| AMENDMENT OF SOLICITATION/MODIFICATION OF CONTRACT | | | 1. CONTRACT ID CODE | PAGE 1 OF 14 PAGES |
| 2. AMENDMENT/MODIFICATION NO. 0001 | 3. EFFECTIVE DATE 12 Dec 06 | 4. REQUISITION/PURCHASE REQ. NO. | 5. PROJECT NO. (If applicable) N/A | |

The purpose of this amendment is to make the following changes to the solicitation: 1). Extend the bid opening, 2). Provide date and time for site visit, and 3). Provide answers to technical questions.

WBB Network Overview

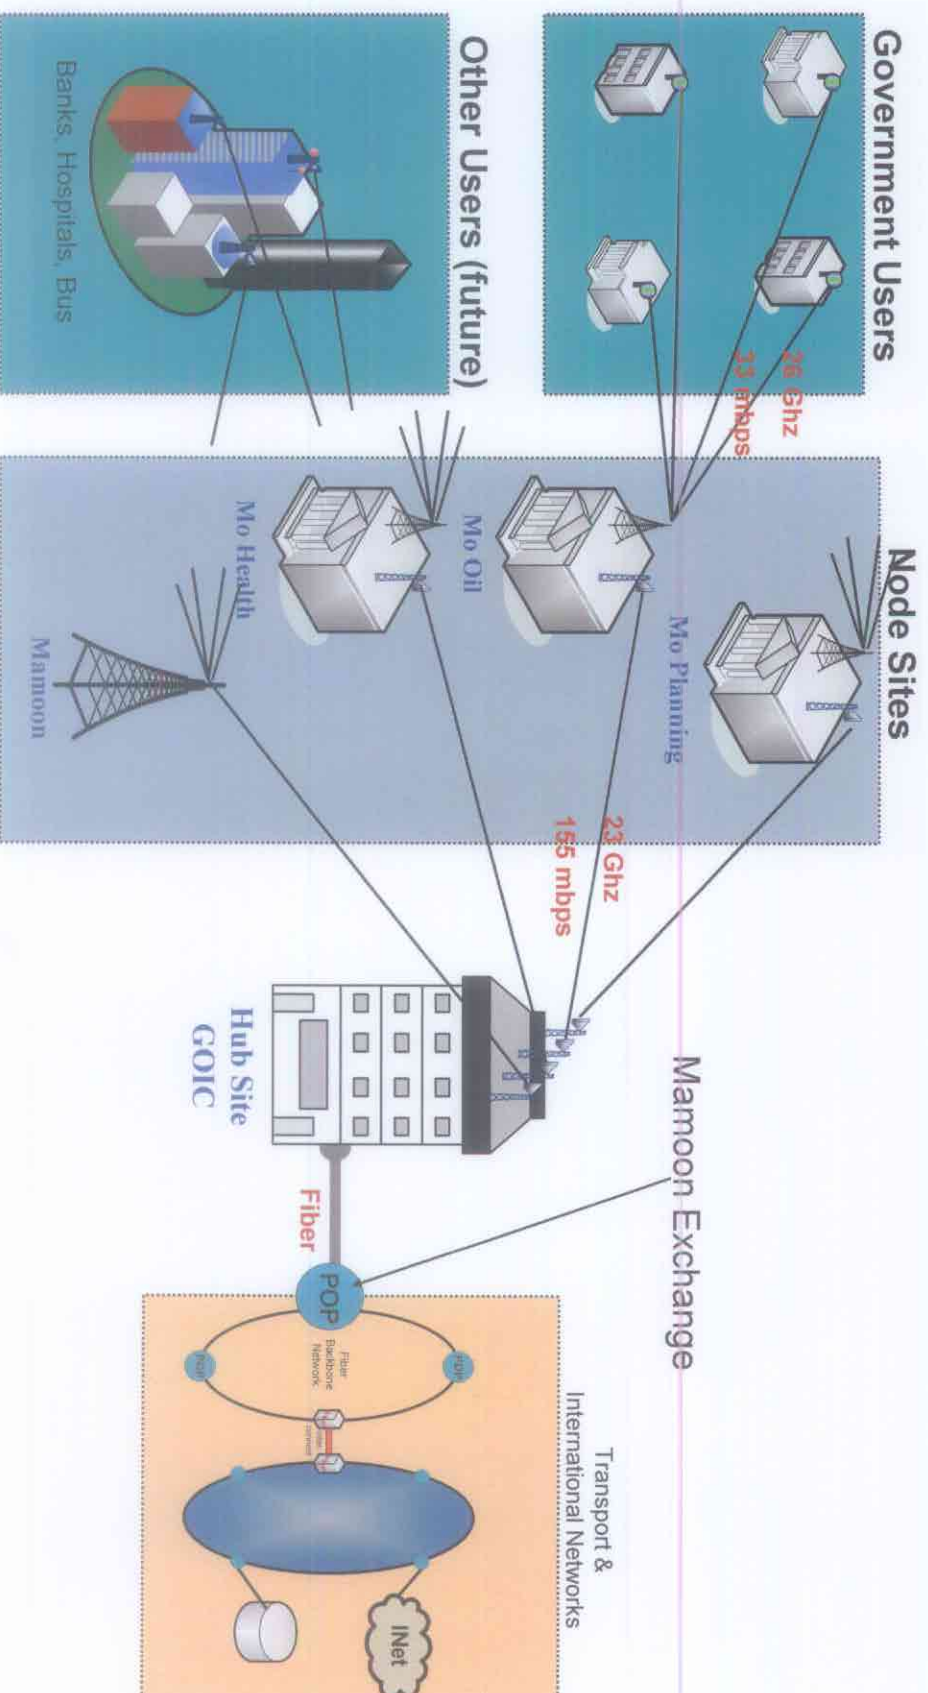
Will the existing WBB network schematics (Point-to-Multipoint) be provided showing the current network routing so that required links can be added if they do not exist? For example, Ministry of Finance (Main), CPI, Prime Minister, Counter Terrorism Bureau and Counter-Terrorism Command in Group 1, and others in Groups 2 and 3.

Can a current architecture diagram be provided?

Power Point Presentation: Attachment 1

Architecture Diagram: Attachment 1

WBB Equipment Example

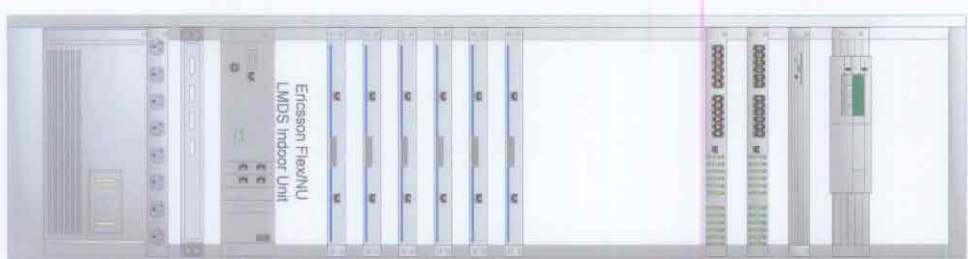
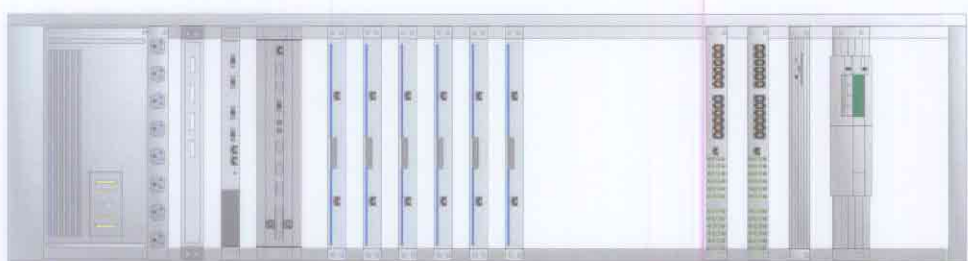
What equipment comprises the LAN/WAN infrastructure? (Router Models, Switch Models, Interface cards and modules)

- a. What is the currently implemented hardware for the existing WBBN? Could the hardware manufacturer and model numbers please be provided? What specific WBBN equipment is required at the 17 sites not currently on the WBBN, including: antennas, base station equipment, routers, and switches? What ports/interfaces are available?

CPE Newtwork Site: Attachment 2

a. CPE Network Site: Attachment 2
